## APPLICATION BY NATIONAL HIGHWAYS FOR AN ORDER GRANTING DEVELOPMENT CONSENT FOR THE PROPOSED A66 NORTHERN TRANSPENINE PROJECT

### CONSULTATION SEEKING COMMENTS FROM THE APPLICANT AND ALL INTERESTED PARTIES

**Deadline 6 Submissions on the A66 Northern Trans-Pennine Project**

# PROPOSED BROUGH HILL FAIR SITE – BIVVY OPTION

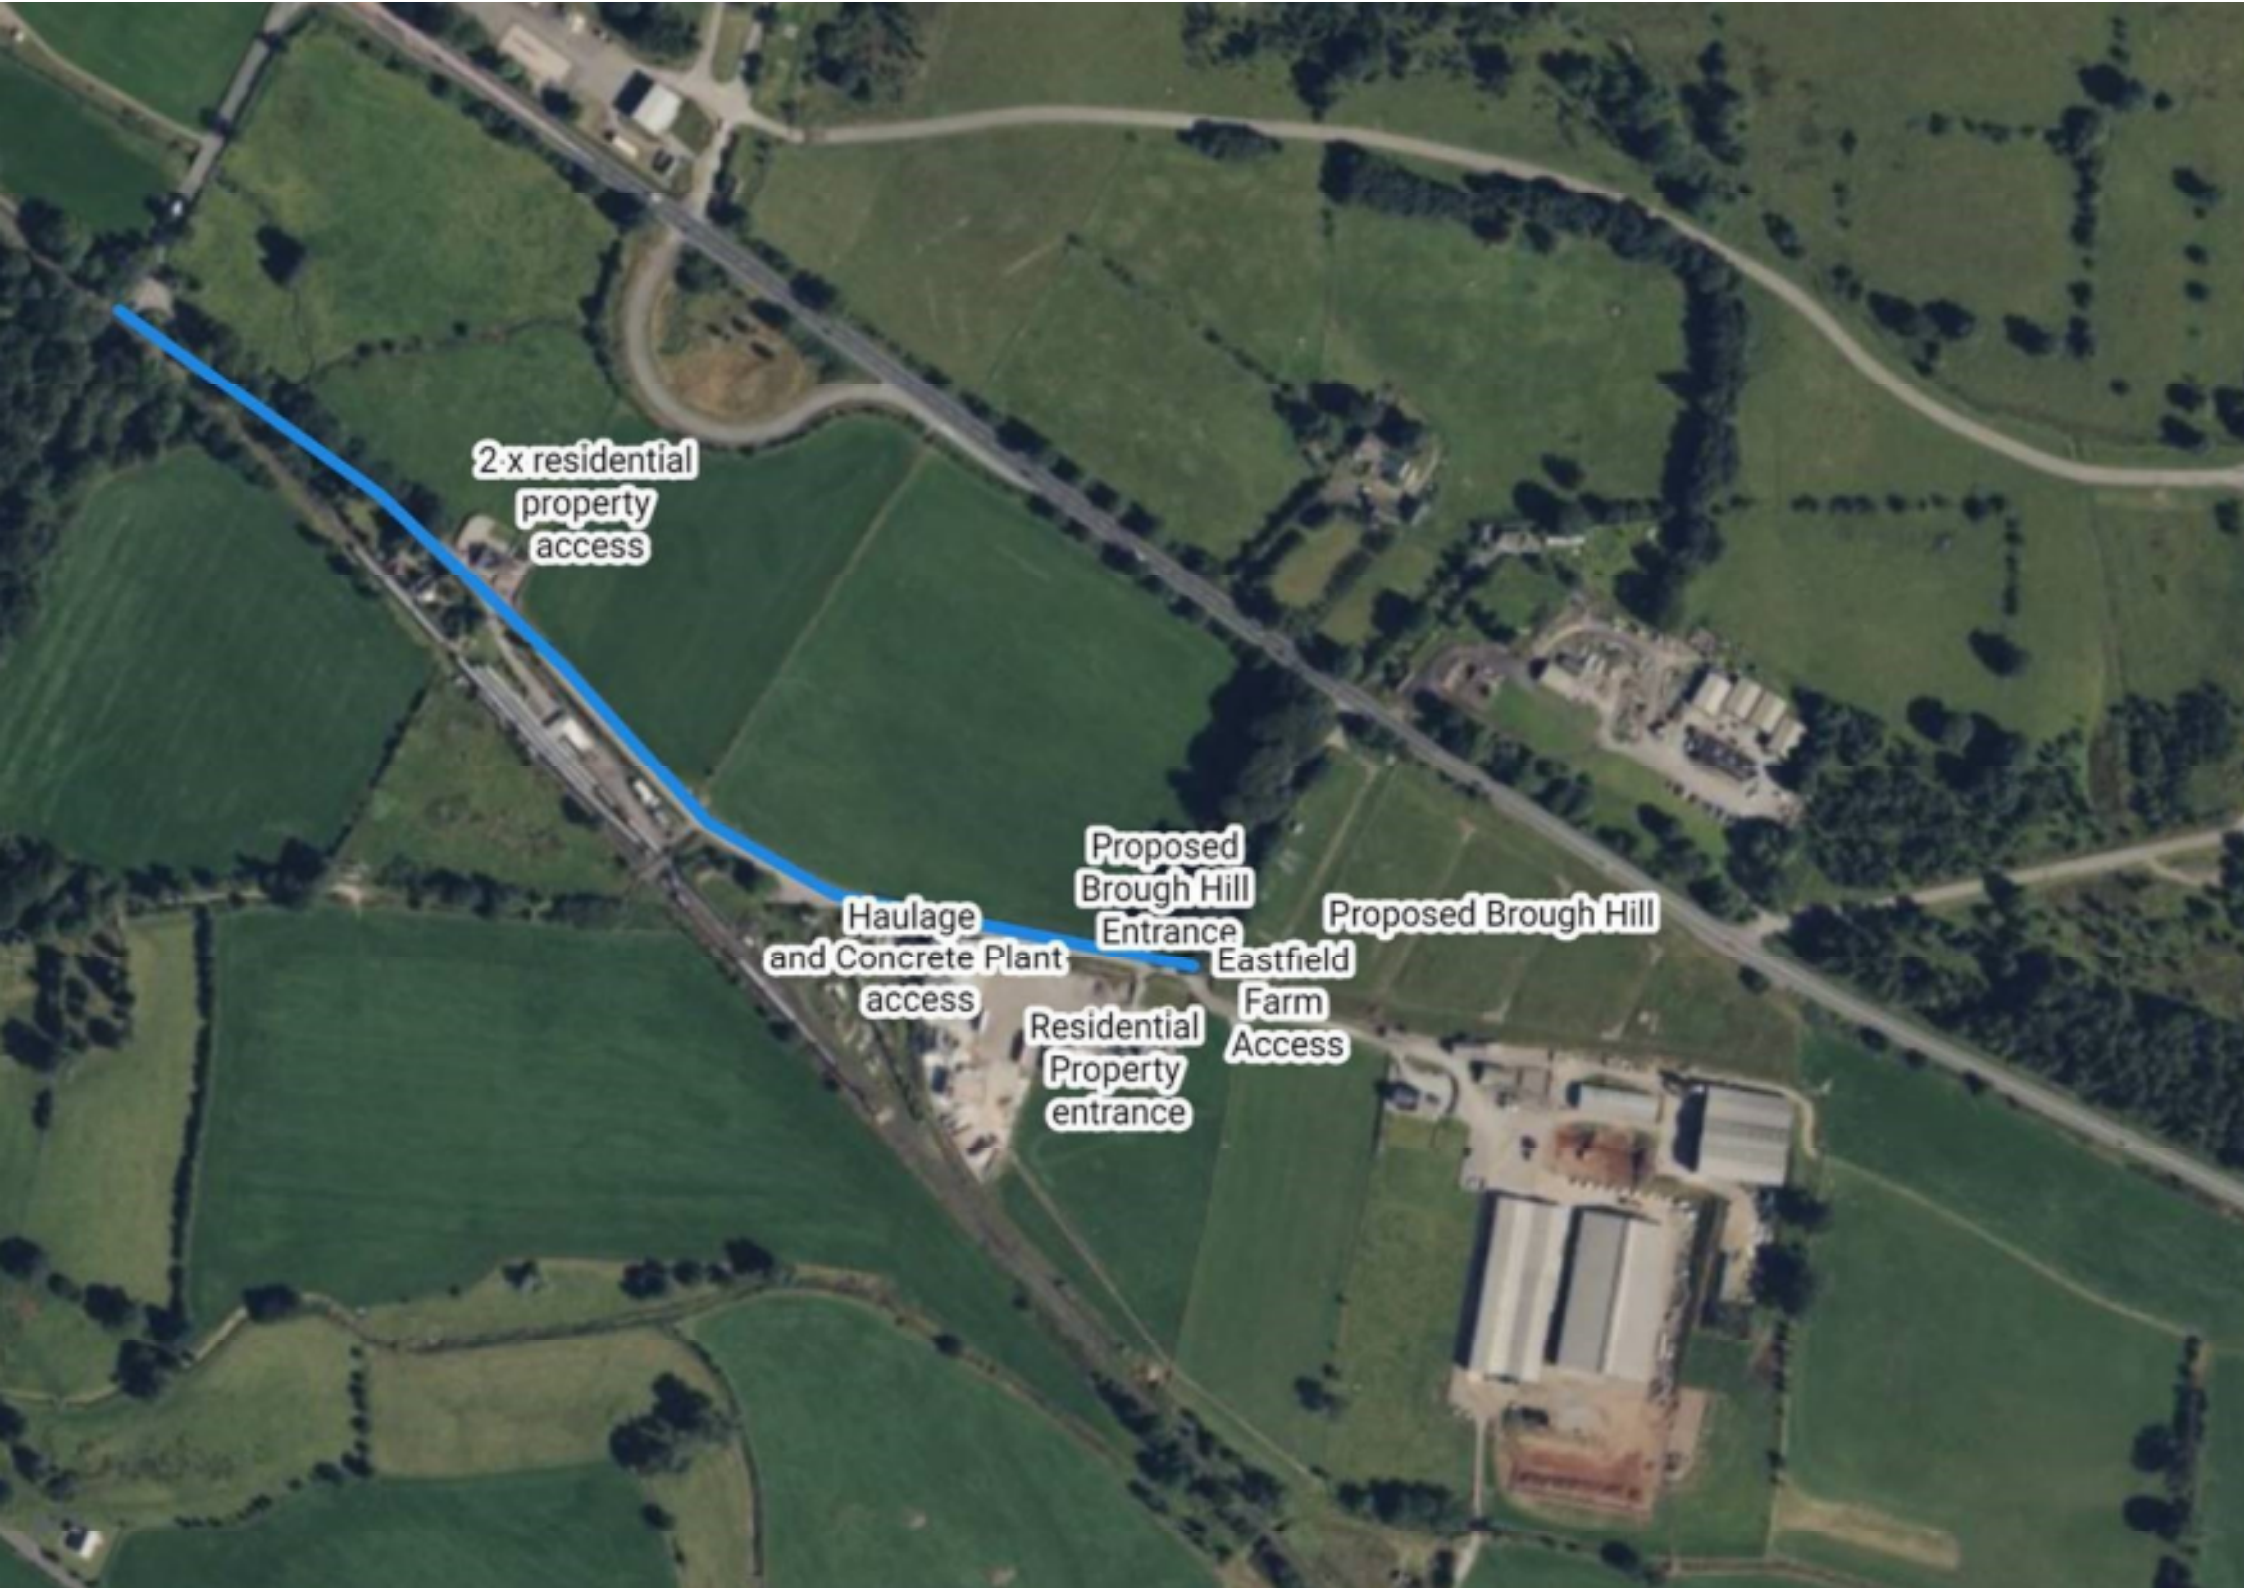
I believe the Applicant has not fully demonstrated the proposed access to the relocation site. The access will use the same access as the haulage yard and farmyard whereby HGV's and machinery will be using the access numerous times every day.

25. Sixth, the conjoined use of the public and private access routes, as shown on Annex C, by heavy vehicles accessing the Concrete Plant 24 hours a day and horse driven vehicles accessing the Bivvy Site for the Fair, is both dangerous and wholly unacceptable. The Representors understand that the Applicant has failed to carry out any risk assessment taking into account the heavy vehicle use of the Concrete Plant or at all.
